MASTER DEVELOPMENT PLAN
CHESTNUT SPRINGS SUBDIVISION

Re: Chestnut Springs Subdivision

MDP # 783-B

The City Staff Development Review Committee has reviewed Chestnut Springs Master Development Plan M.D.P. # 783-B. Please find enclosed a signed copy for your files. Your plan was accepted, however please note the following:

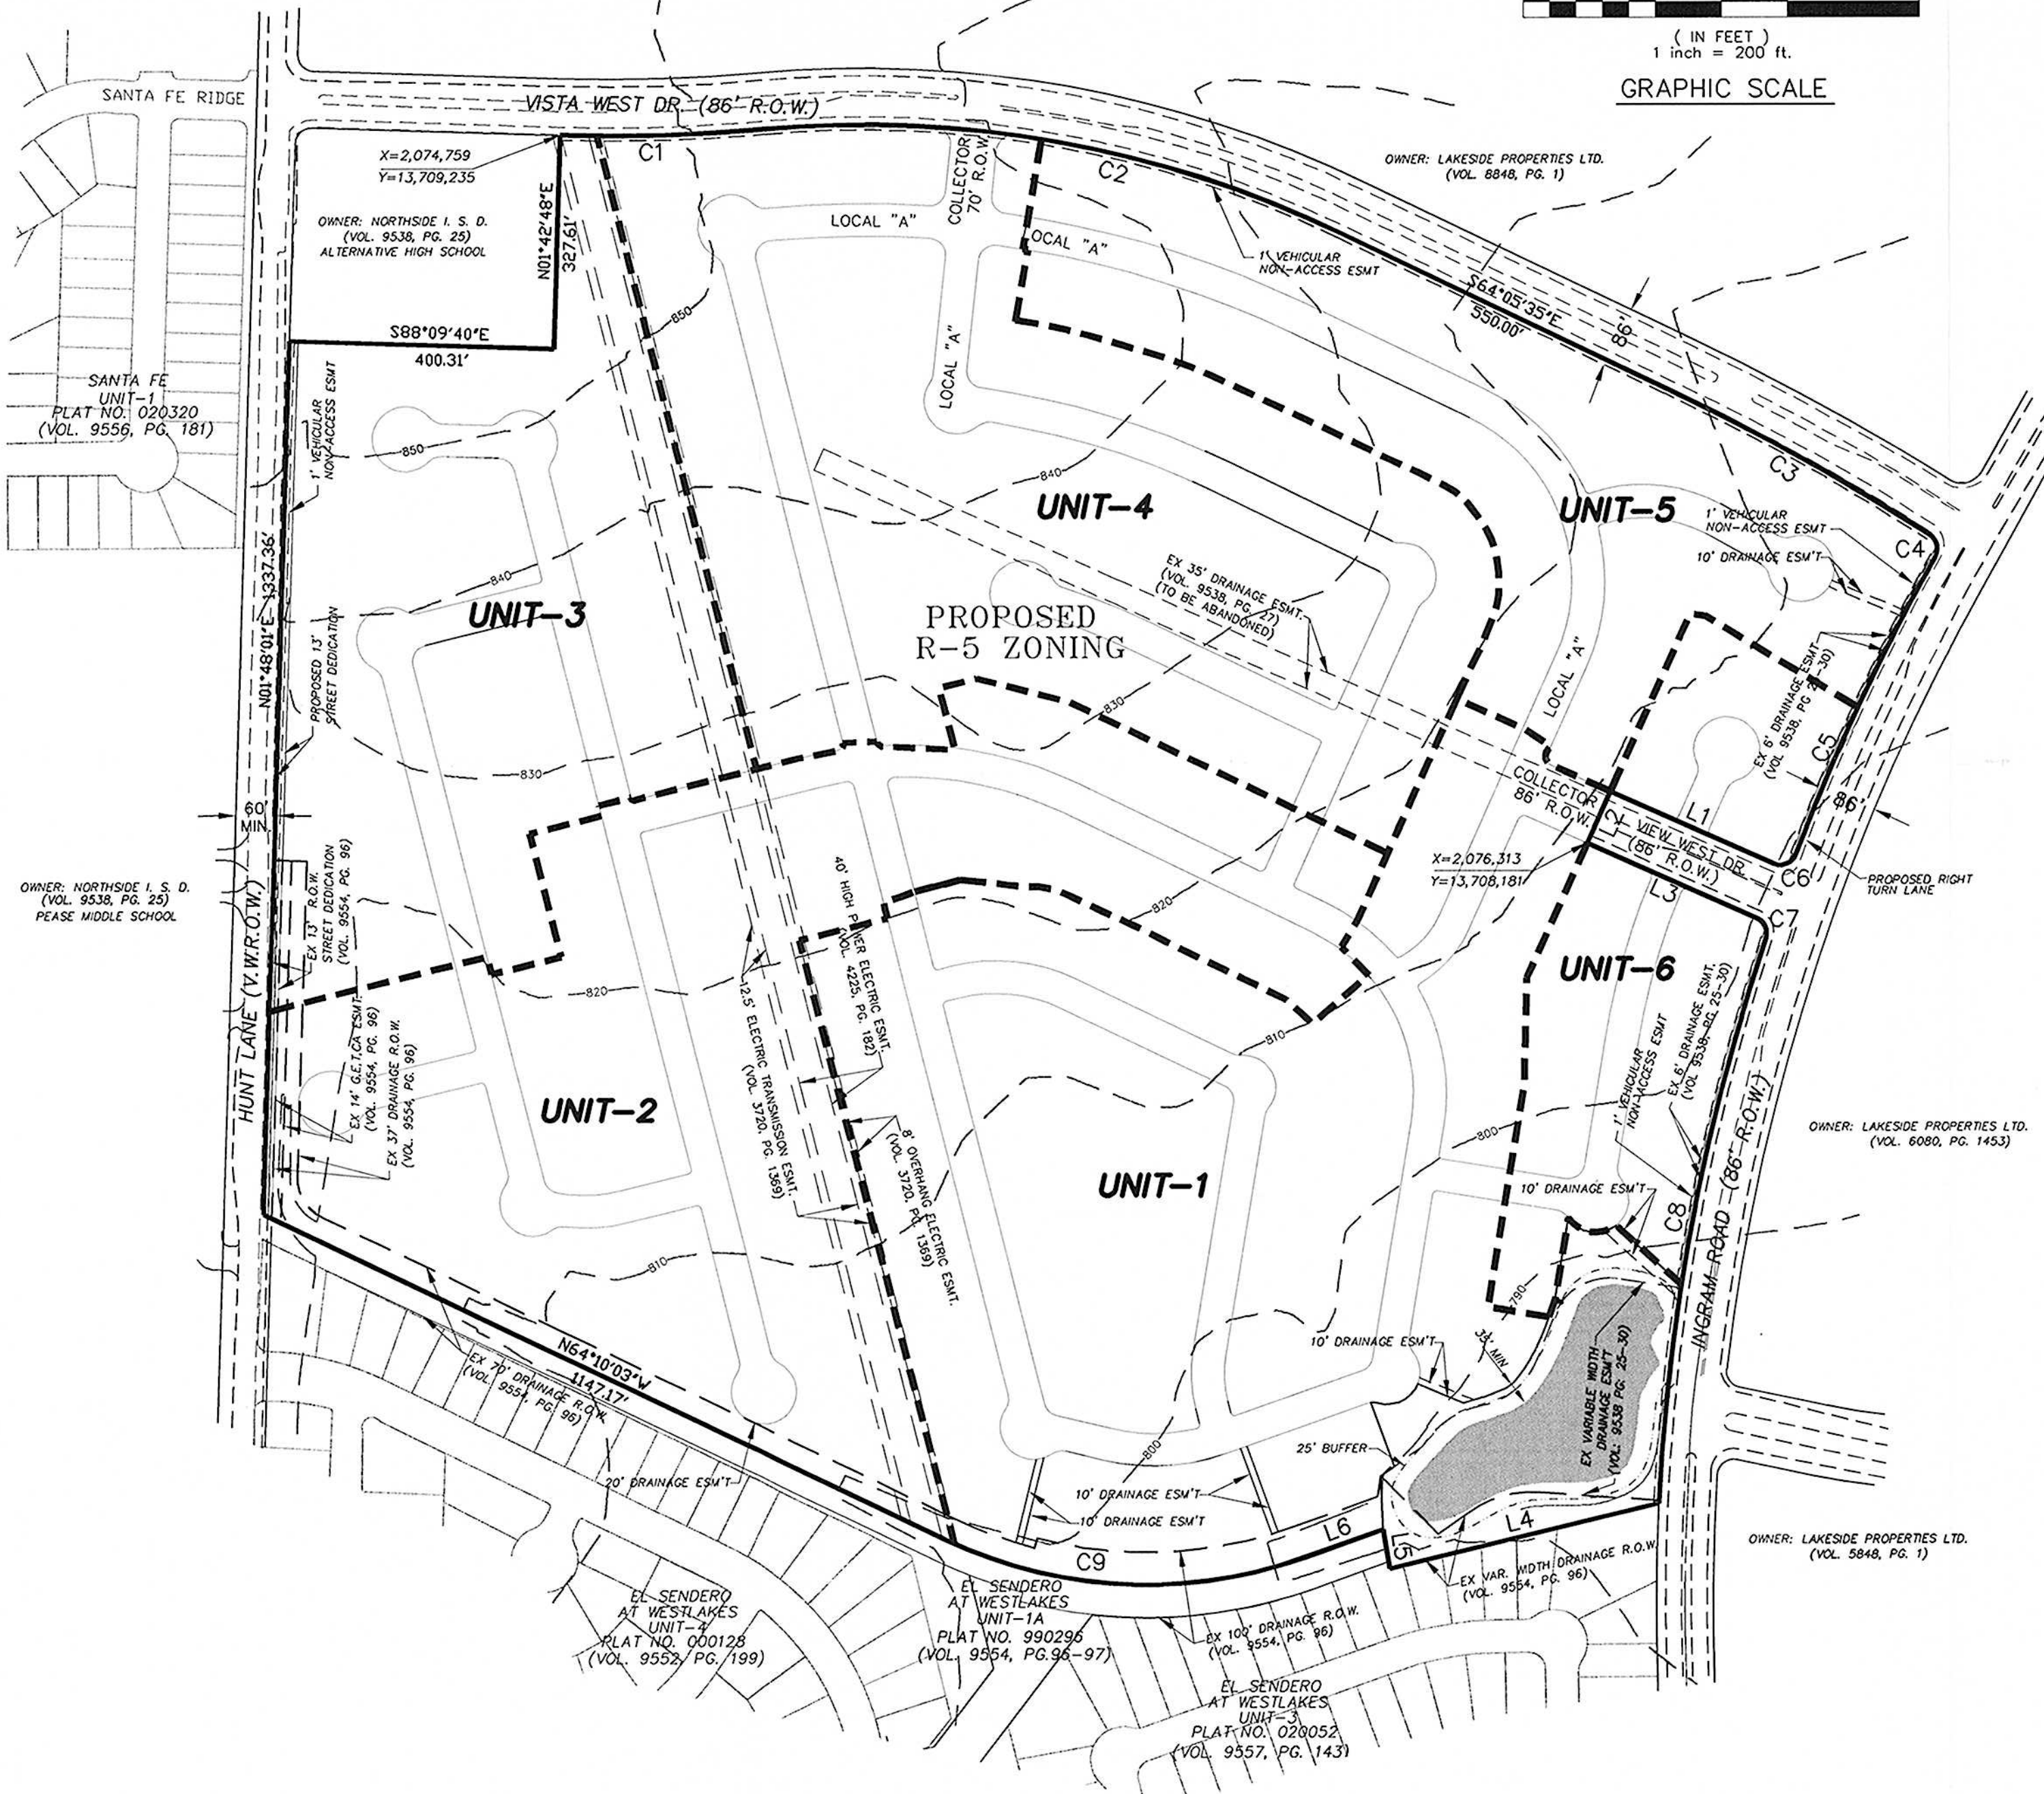
- In consideration of public safety and convenience, excessive grades by reason of topography should be avoided in street layouts and arrangements.
- Development Services, Engineering Section has indicated as part of their conditional approval, The following on-site improvements, as well as, improvements along the project limits are necessary and shall be provided by the developer, on or before the completion of the Chestnut Springs Subdivision, at no cost to the City of San Antonio:
 1. Provide 43 ft. right-of-way from the centerline of Hunt Lane along the frontage of this property.
 2. Construct a southbound right-turn lane on Ingram at the collector entrance to this subdivision.
 3. All interior streets accessing external roadways shall follow all conditions set forth in the Chestnut Springs Master Development Plan.

4. It should be understood that the submitted TIA is a conceptual plan and therefore this document does not represent an approval for the internal street plan.

- Any access and R.O.W. issues along state facilities will need to be resolved with the Texas Department of Transportation (TXDOT). For information about these requirements you can contact TXDOT at 615-5814.
- This development will need to comply with tree preservation ordinance #85262. For information about these requirements you can contact Tree Preservation at 207-8053.
- It will be expected that you will plat all of the property depicted in your Master Development Plan (M.D.P.) to include floodplains, drainage areas and open space.
- Storm Water Engineering has reviewed the above reference project. Based on the submittal dated January 8, 2004 comments are as follows:

1. This project is eligible for regional storm Water Management Participation (FILO).

- I would encourage you to work closely with the school district, so that they can plan accordingly.
- This development will need to comply with tree preservation ordinance #85262. For information about these requirements you can contact Tree Preservation at 207-8053.

- The Parks and Recreation Department as part of their conditional approval impose the following:
 1. Chestnut Springs is a proposed subdivision of 489 units. Per the requirements of the UDC Section 35-503, the parkland dedication requirement for this subdivision is 4.3 acres. Chestnut Springs will develop a 3.17-acre park in the southeast corner of the subdivision encompassing the existing pond. The three required improvements will be addressed at the platting stage. Once the required improvements are completed a transfer date will be set to dedicate the park to the City of San Antonio. The park and all improvements must be completed prior within the first two phases filed under this plan.

2. A fee in-lieu of dedication will be paid on the remaining dedication requirement of 1.13 acres. The fee will be set at the platting stage and is to be paid in full prior to recordation of the first plat filed under this plan.
